ADDENDUM NO. 1
November 3, 2020

- A. Brooks Stadium East Gates, H17-N123-MJ
Coastal Carolina University, Conway, SC

CCU BROOKS STADIUM EAST GATES CONWAY, SC

sheet number
A102

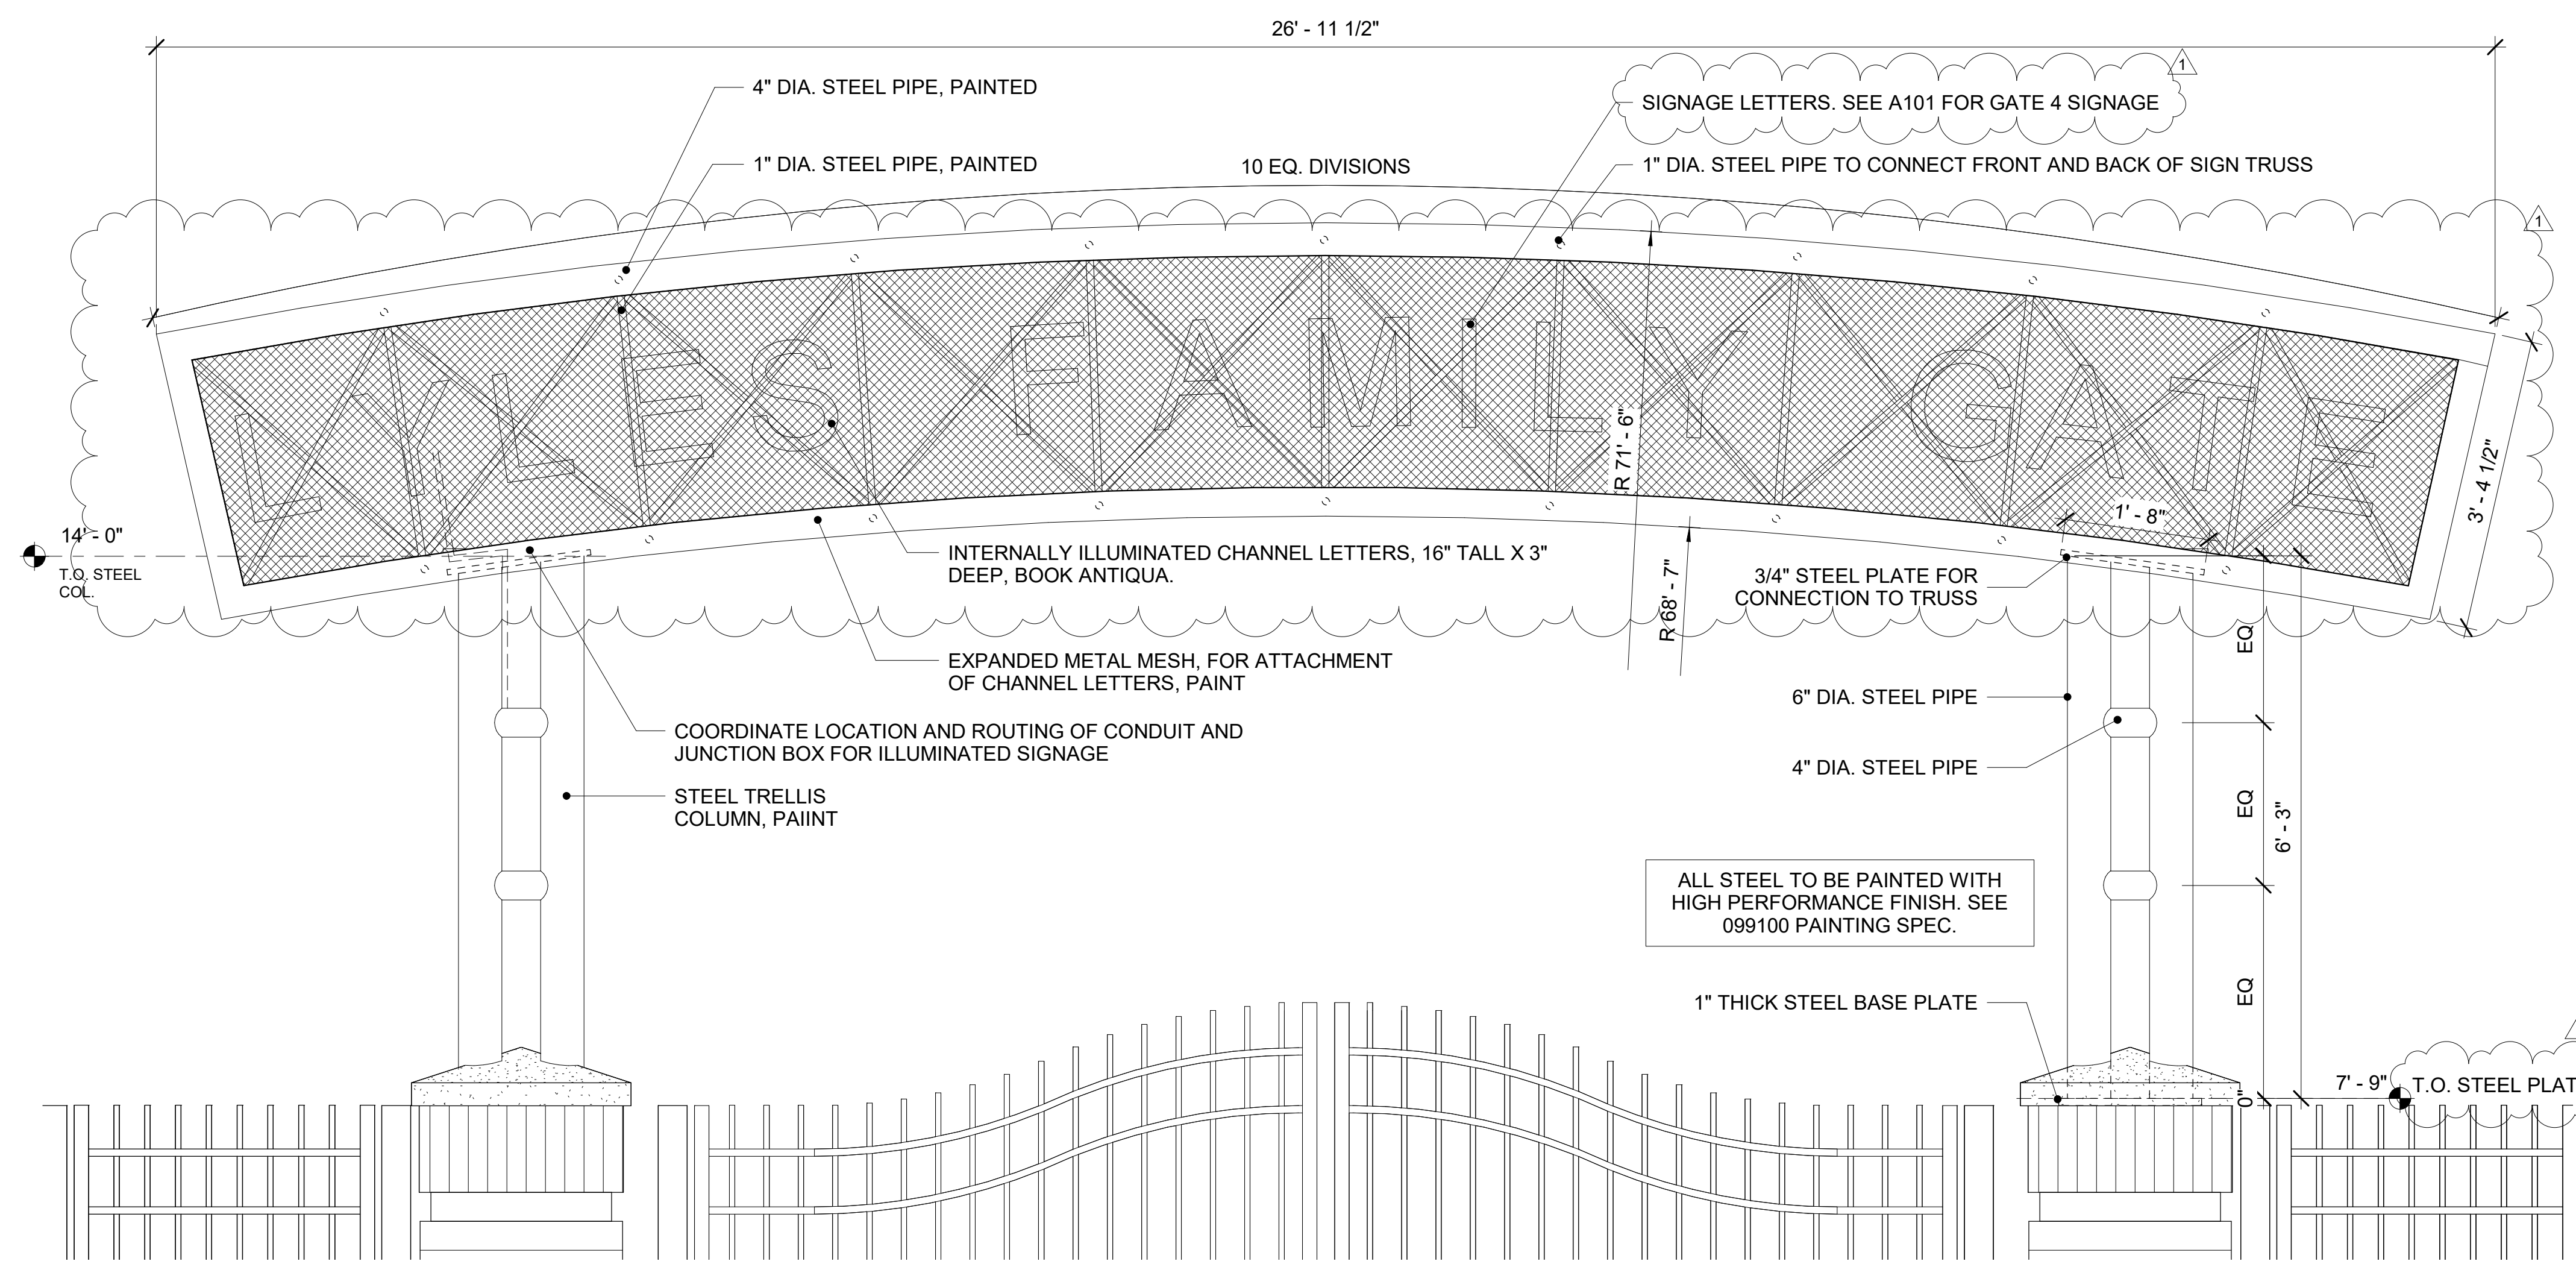
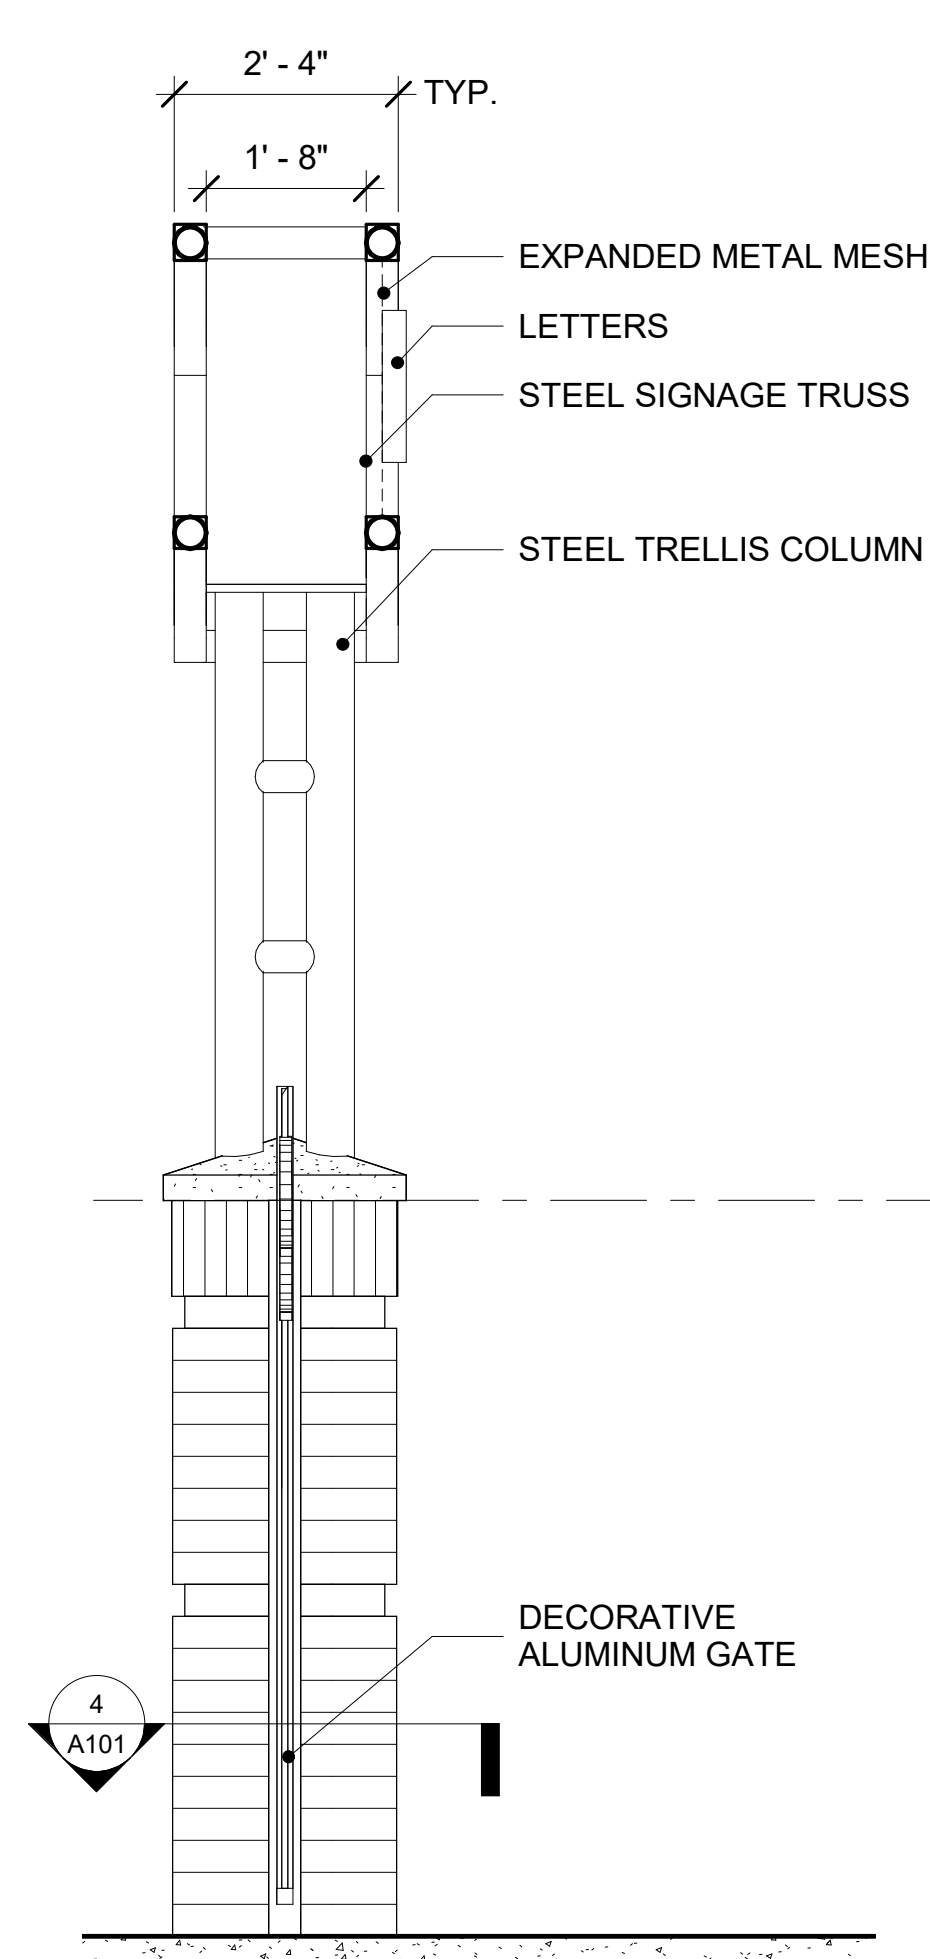
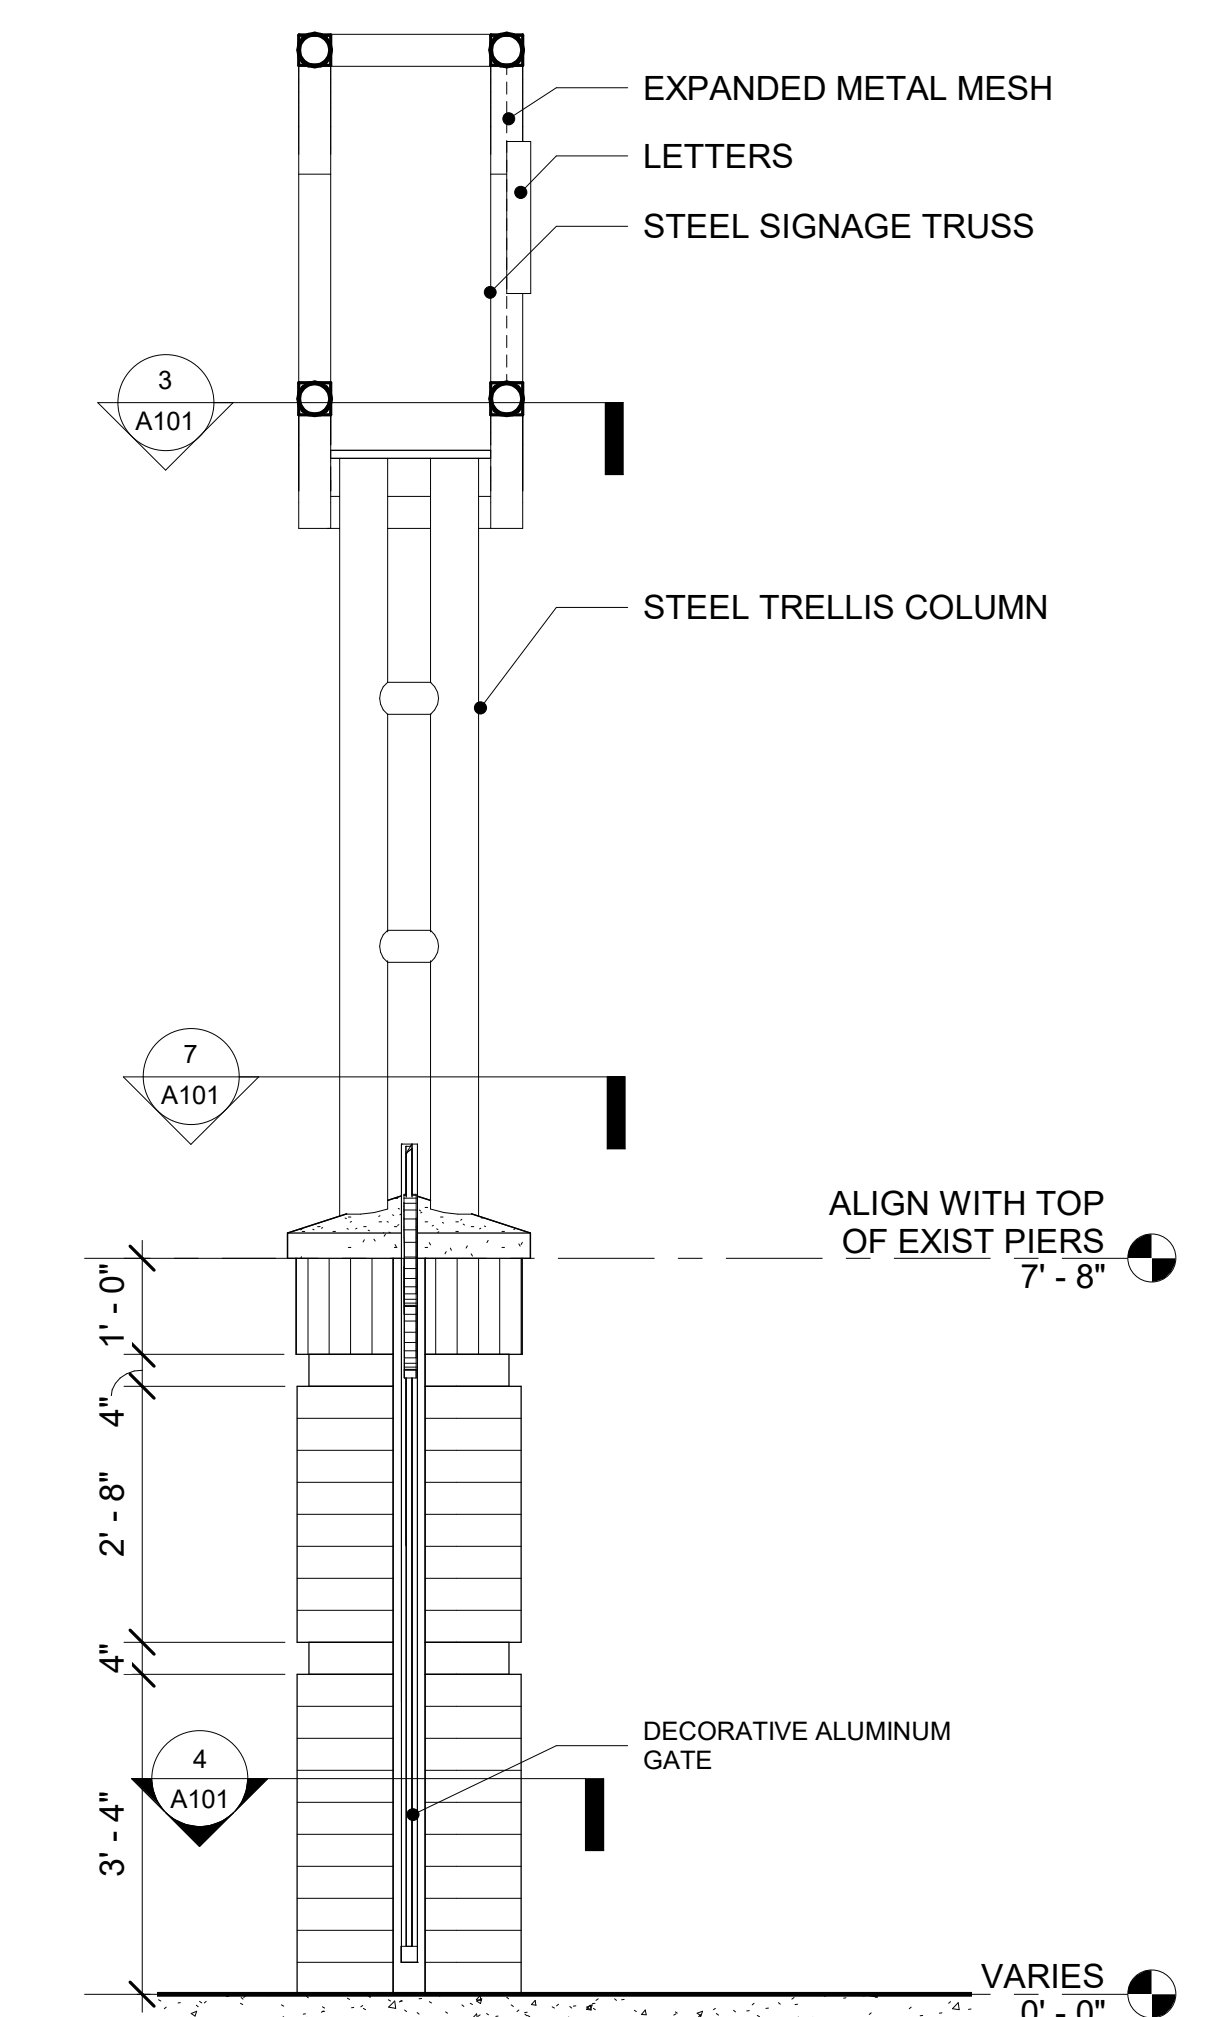
C. Sheet A102. Replace sheet with revised sheet A102 with 10/28/2020 revision date. A summary of revisions is as follows:

1. Clarified Gate Numbers on details.
2. Clarified extent of wire mesh on all gate trusses.
3. Changed letter size on all gate signage to 16” for each gate.
4. Deleted requirement for galvanizing steel fabrication.

- A. Sheet S102. Views 6, 7, and 8. Clarification. Expanded metal mesh shall be provided on one side (signage side) of each truss only. Refer only to revised architectural drawings for extent.
